Project: San Angelo ISD Paging Upgrade (RFP #26-008)

Subject: Addendum 01

TECHNOLOGY ITEMS FOR ADDENDUM 01

GENERAL NOTES AND SYMBOLS

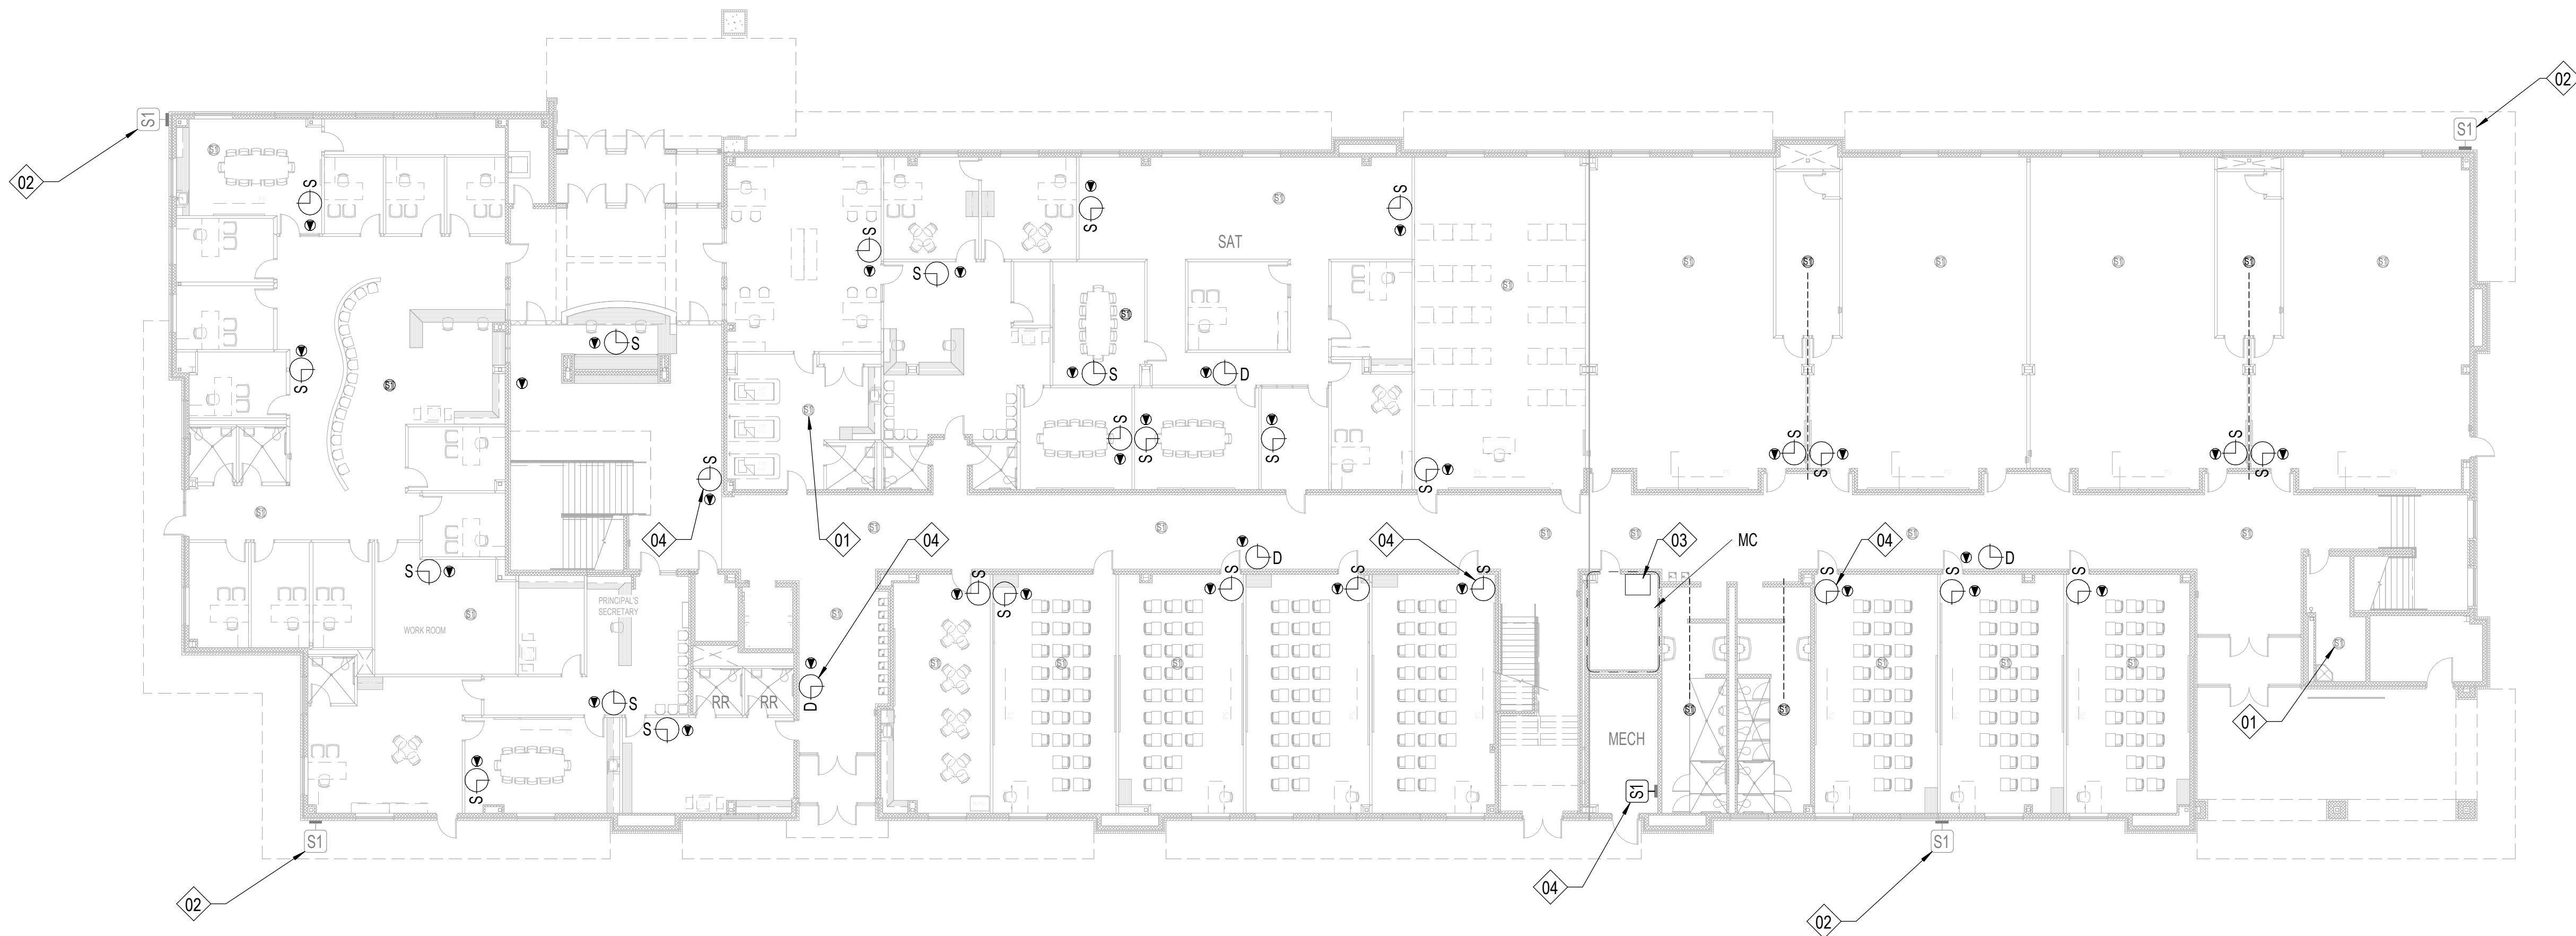
ADD No 1, Tech. Item 2: **To the Drawings, Sheet TG101, "GENERAL NOTES AND SYMBOLS,"**

- 1) Added AVR audio/video rack to "Audio Visual Symbols Legend" and reduced description on other listed AV components.
- 2) Adjusted placement/size of "Paging Matrix" and "Public Address System And Clock Symbols Legend", no content changed.

FLOOR PLAN - CENTRAL
HS - BUILDING B - SOUSA
HALL

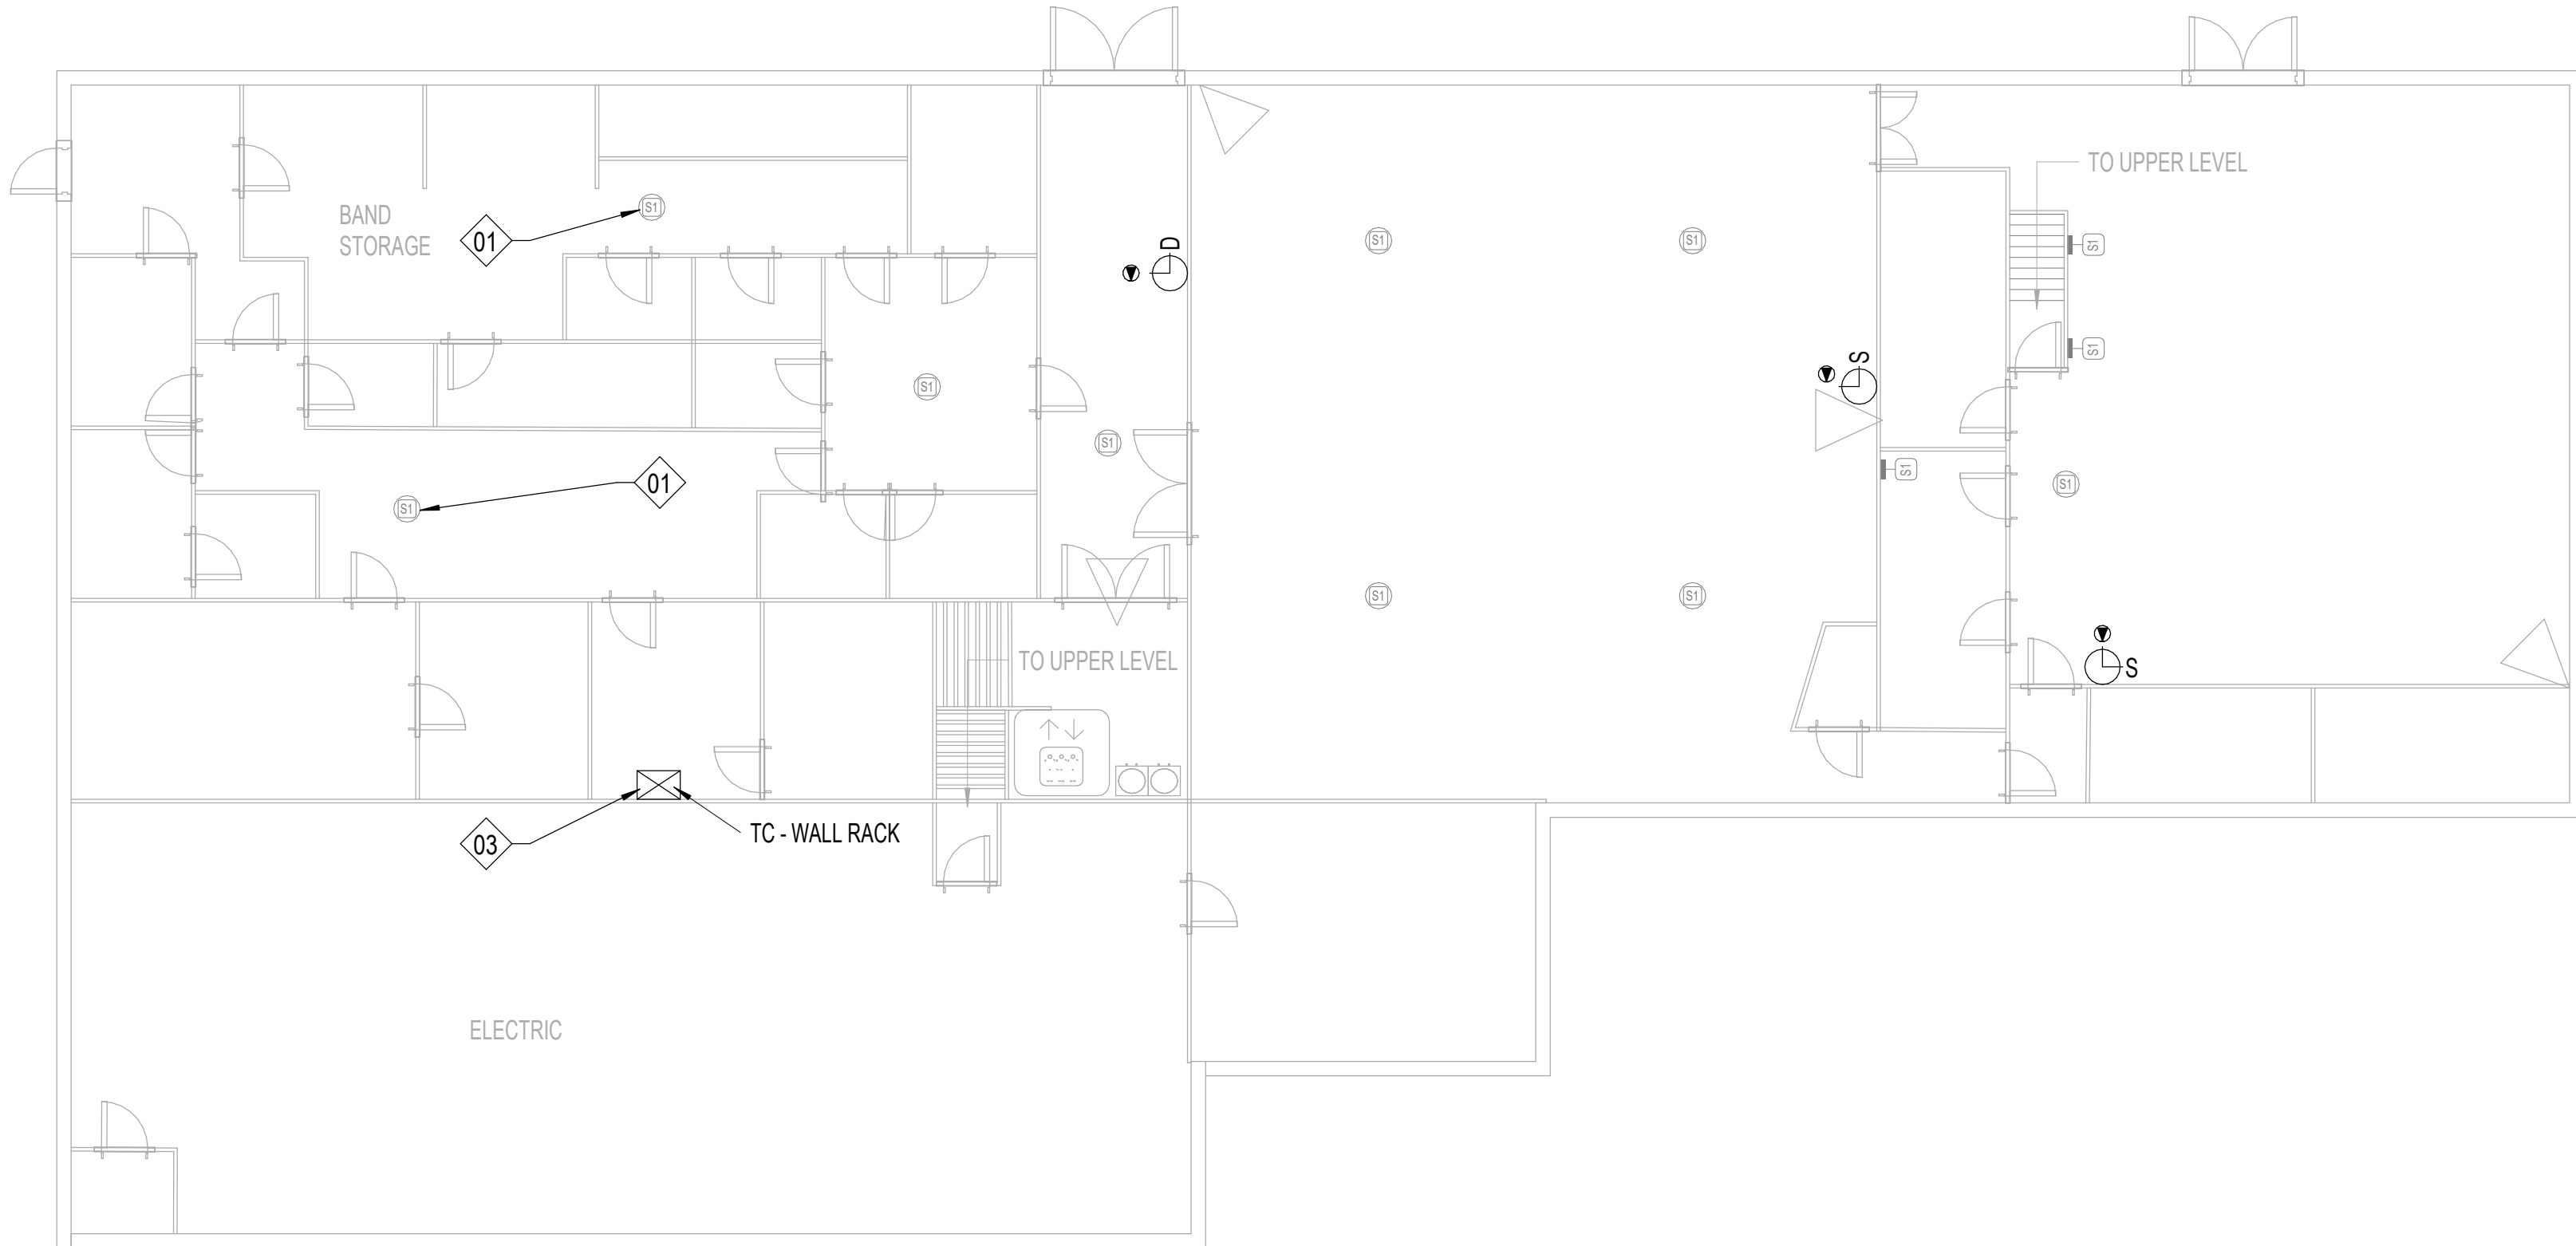
ADD No 1, Tech. Item 4: **To the Drawings, Sheet T102, "FLOOR PLAN - CENTRAL HS - BUILDING B - SOUSA HALL,"**

- 1) Added halftone speaker clarification to Sheet Notes.
- 2) Added paint/finish clarification to Sheet Notes.
- 3) Clarified high-ceiling lift requirement item in Sheet Notes.
- 4) Modified/consolidated Keynote 16/17.
- 5) Changed verbiage of ADD ALTERNATE #3 note.

FLOOR PLAN - CENTRAL
HS - BUILDING D - KELTON
AG

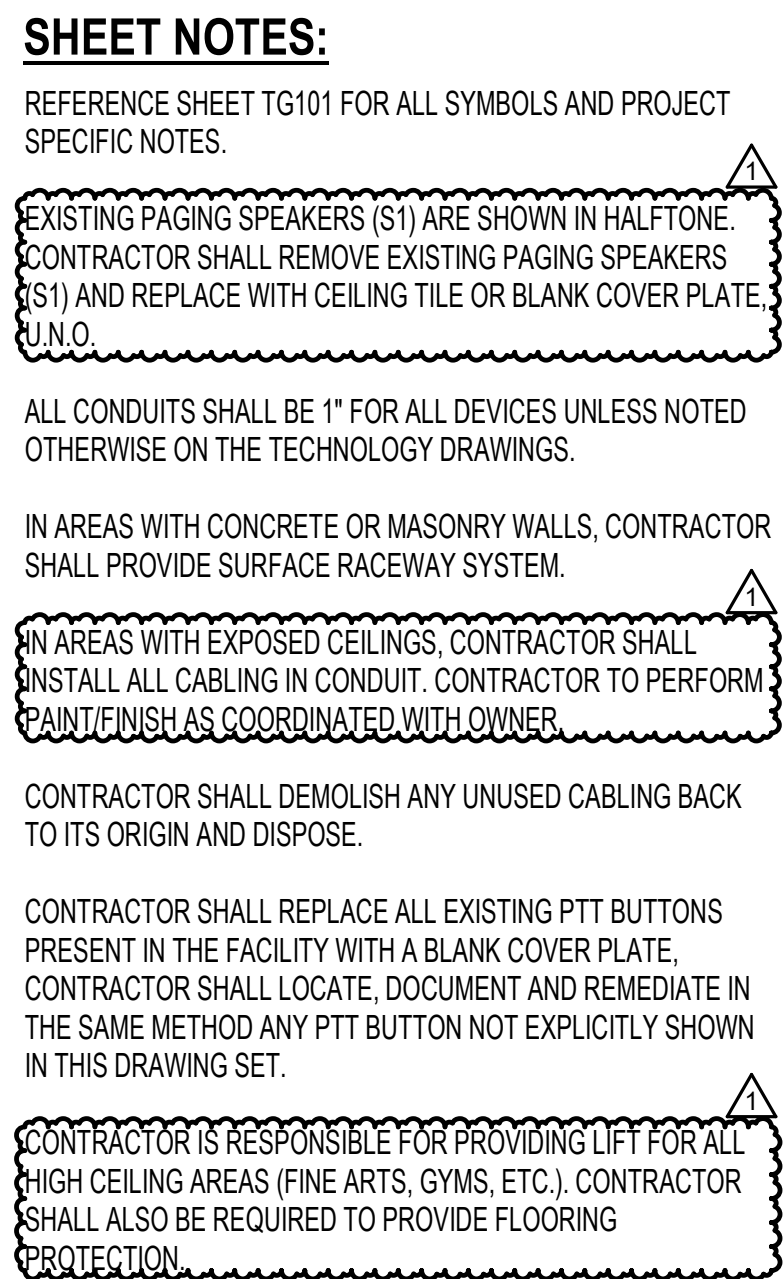
ADD No 1, Tech. Item 7: To the Drawings, Sheet T105, “FLOOR PLAN - CENTRAL HS - BUILDING D - KELTON AG,”

- 1) Added halftone speaker clarification to Sheet Notes.
- 2) Added paint/finish clarification to Sheet Notes.
- 3) Clarified high-ceiling lift requirement item in Sheet Notes.
- 4) Modified/consolidated Keynote 16/17.

FLOOR PLAN - CENTRAL
HS - BUILDING G -
MICHELANGELO

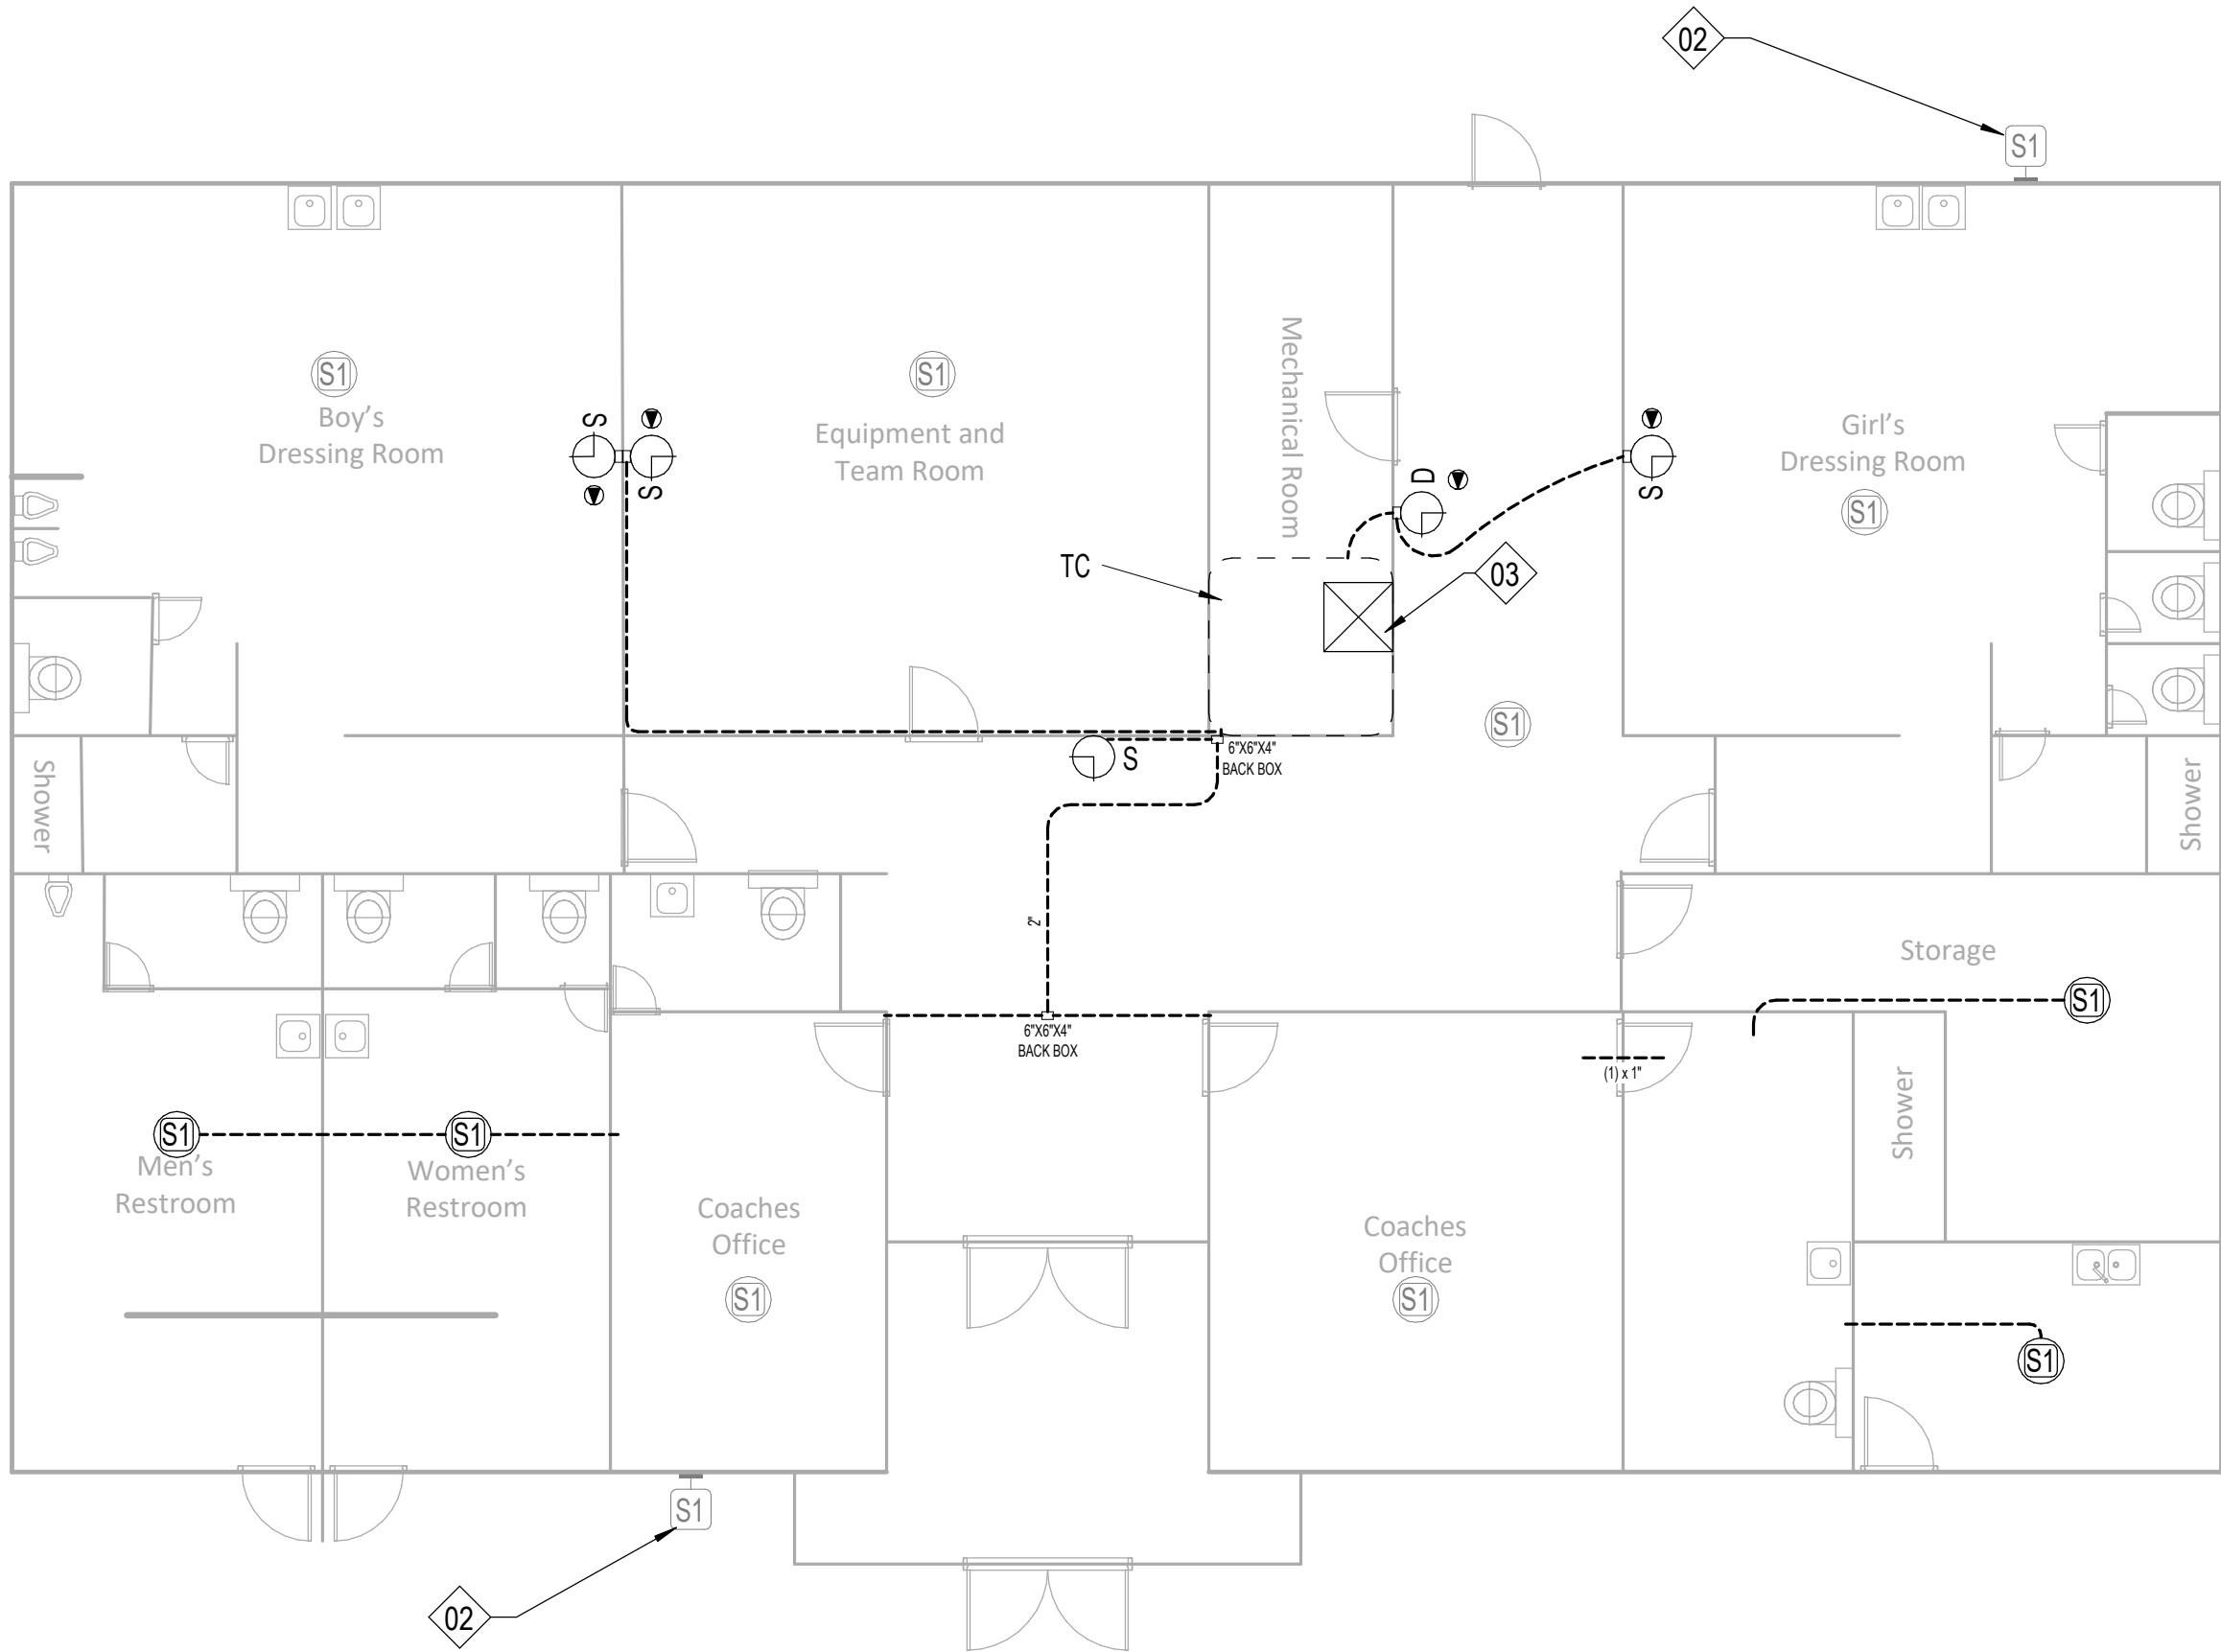
ADD No 1, Tech. Item 10: To the Drawings, Sheet T108, “FLOOR PLAN - CENTRAL HS - BUILDING G - MICHELANGELO,”

- 1) Added halftone speaker clarification to Sheet Notes.
- 2) Added paint/finish clarification to Sheet Notes.
- 3) Clarified high-ceiling lift requirement item in Sheet Notes.
- 4) Modified/consolidated Keynote 16/17.
